Mt Olive Creek Solar, LLC  
Response to Siting Board's Initial Request for Information  
Case No. 2020-00226

Request No 1: Refer to the Application, Attachment I, pages 1 and 4.

# Mt Olive Creek Solar: Nearest Noise Receptors

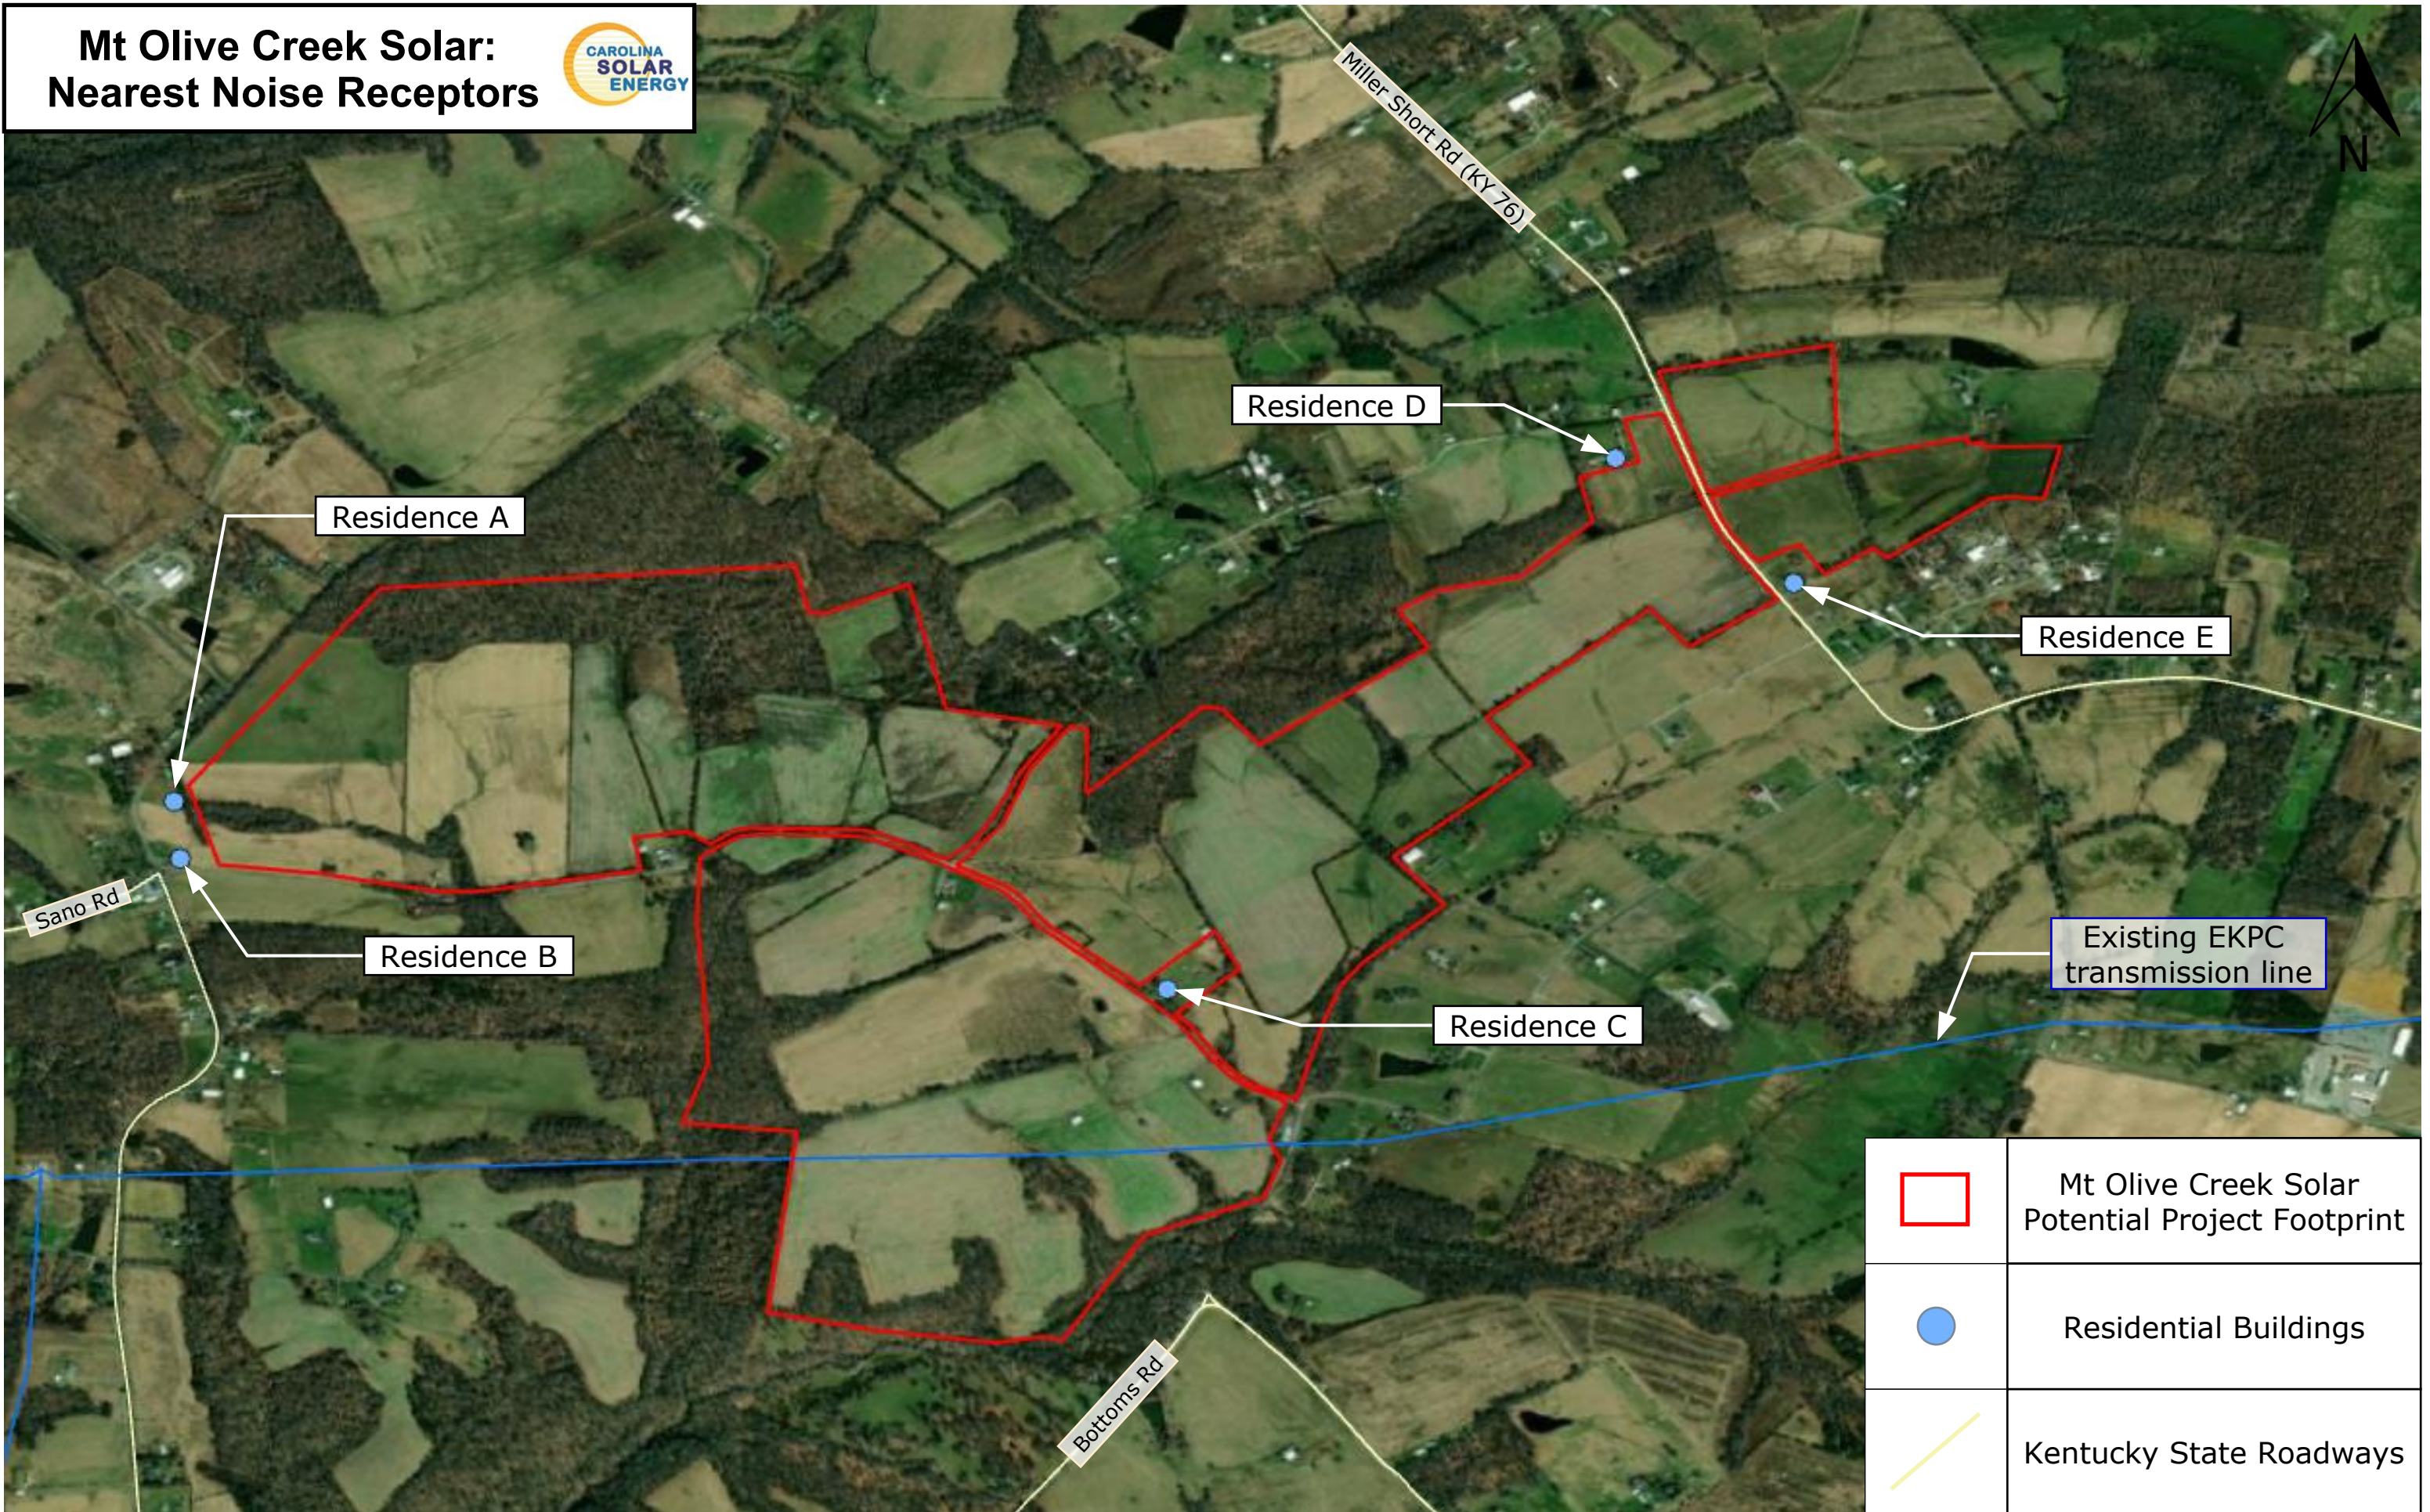
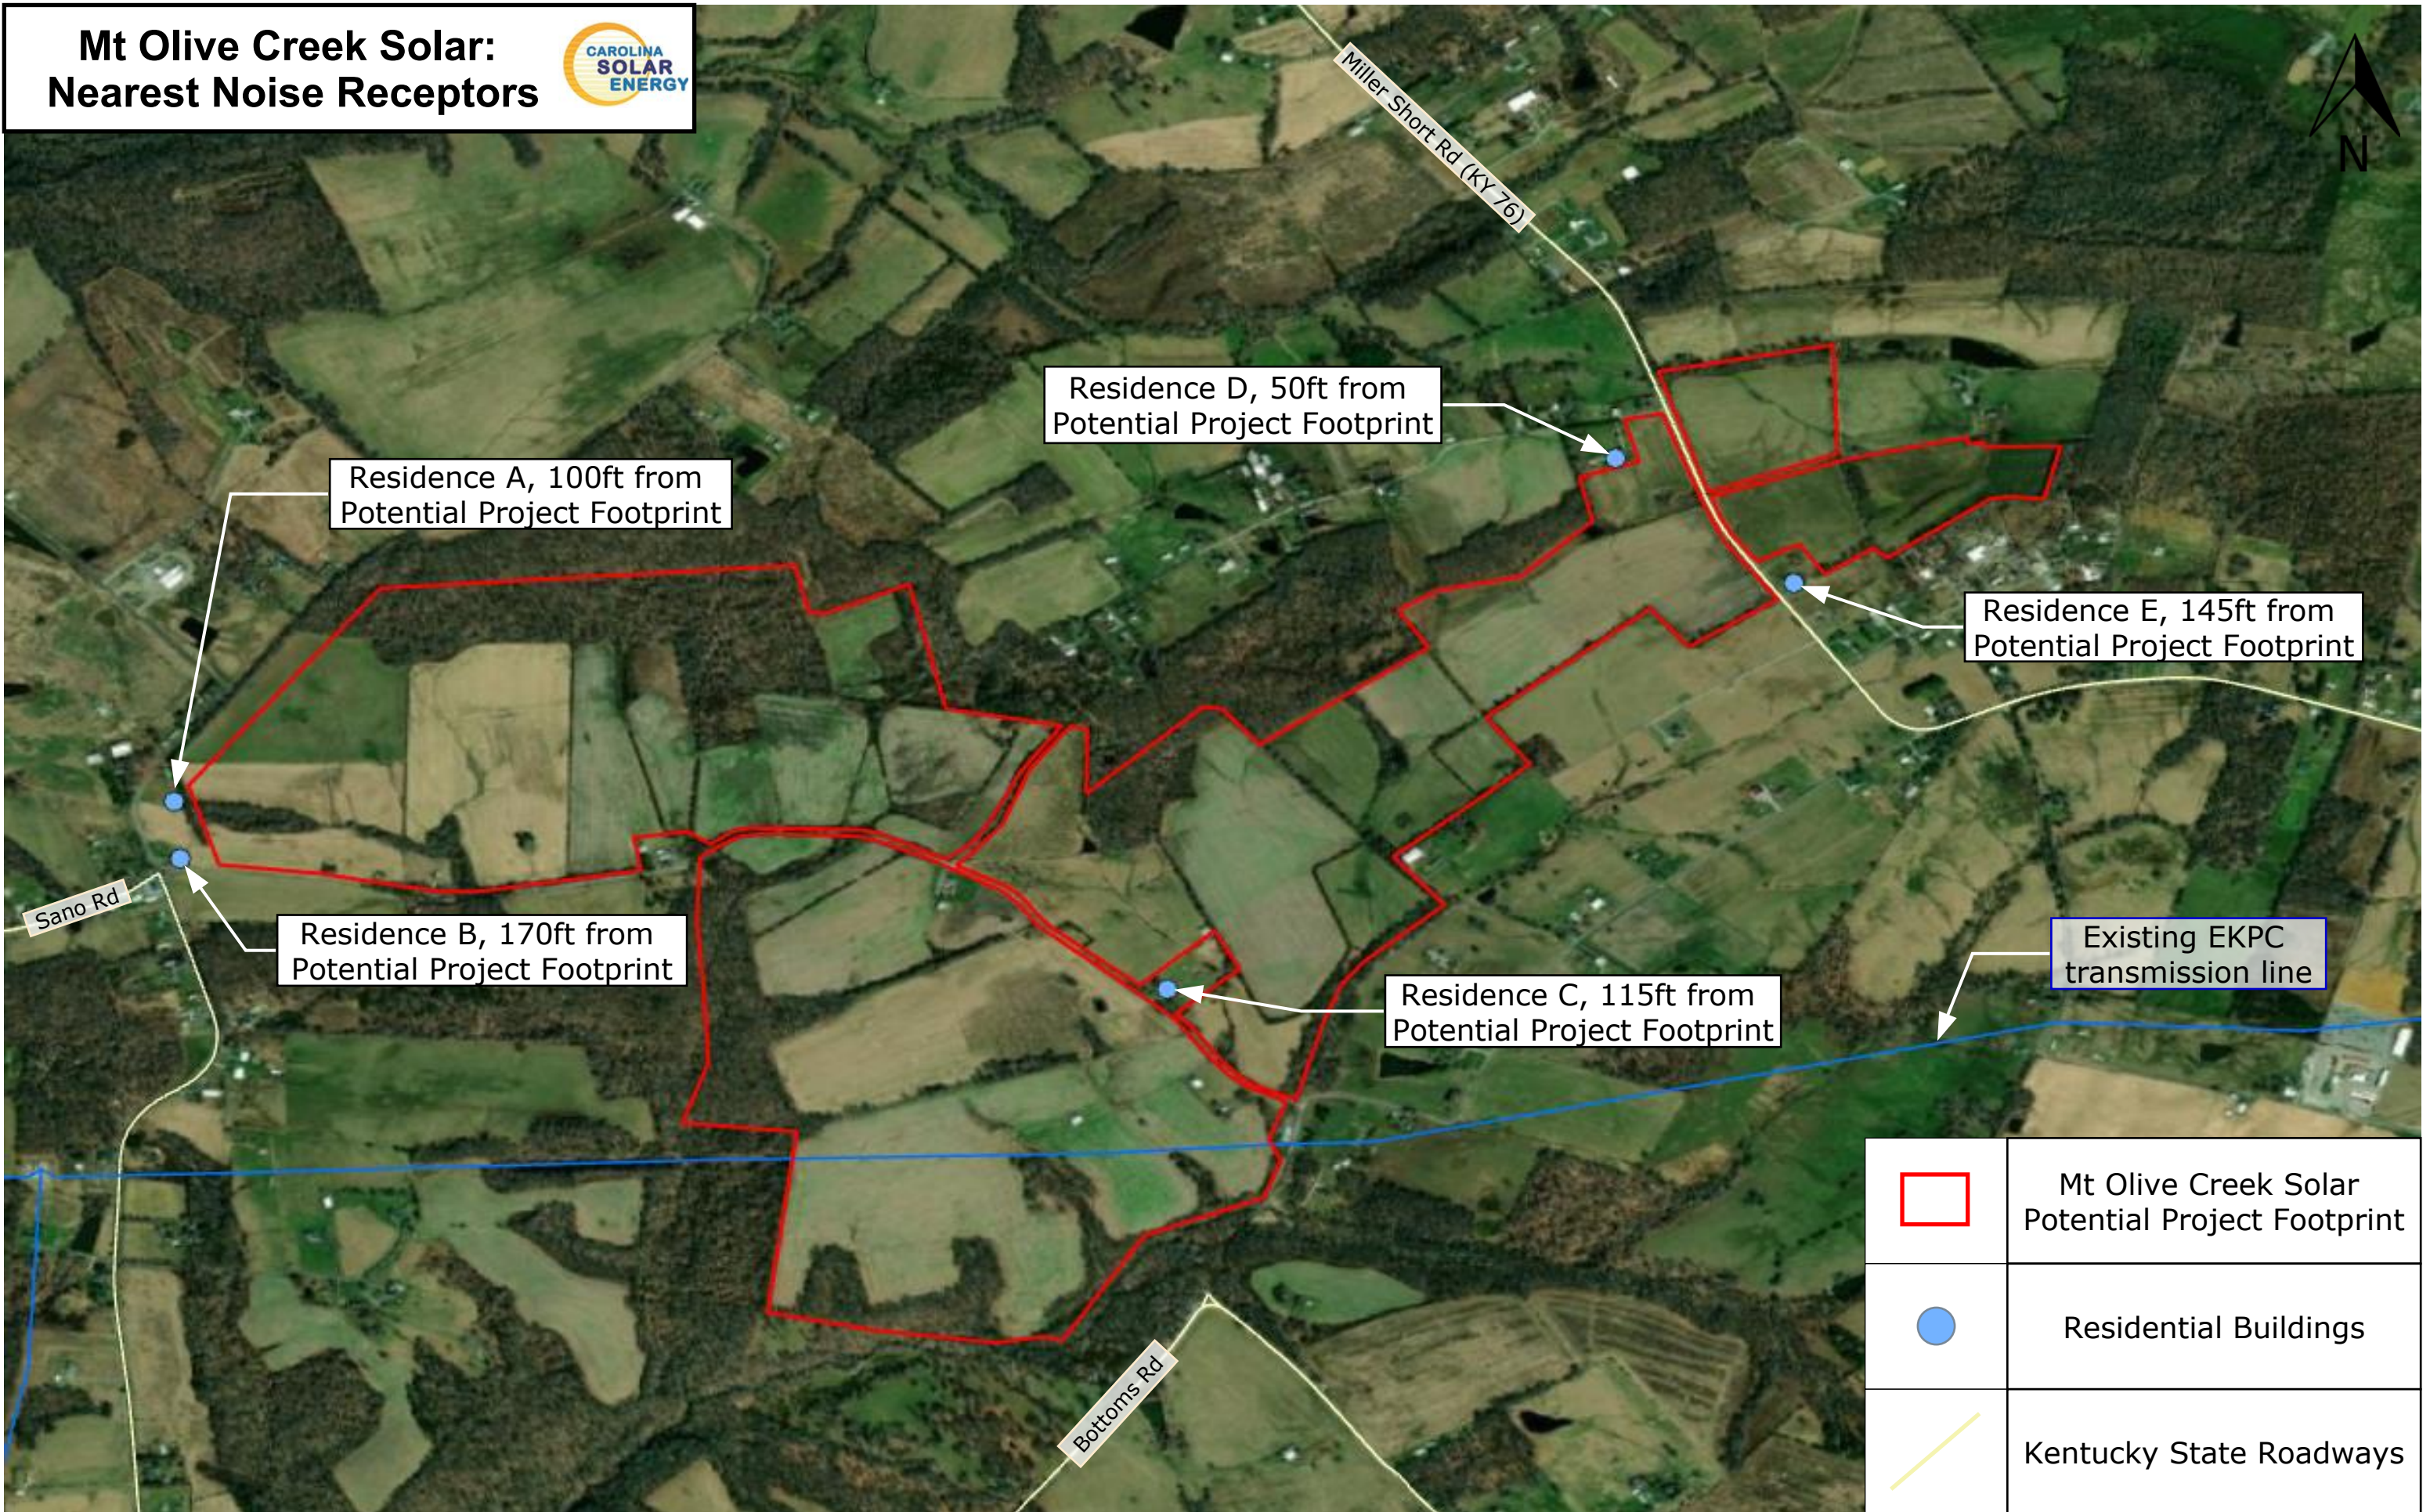
Request No 9: Provide the distance from the string inverters to the five nearest sound receptors and the anticipated noise level measured in dBA

Response: Please refer to the map provided here, showing the locations of the five closest non-participating residential homes to the project.

The distances in the table below assume the setbacks proposed in the Application. Please note the site design is not finalized, so these are the minimum distances that the project will be from noise receptors. The actual distances will vary based on the final site plan, which will be designed once the sourcing decisions are made and equipment chosen for the facility.
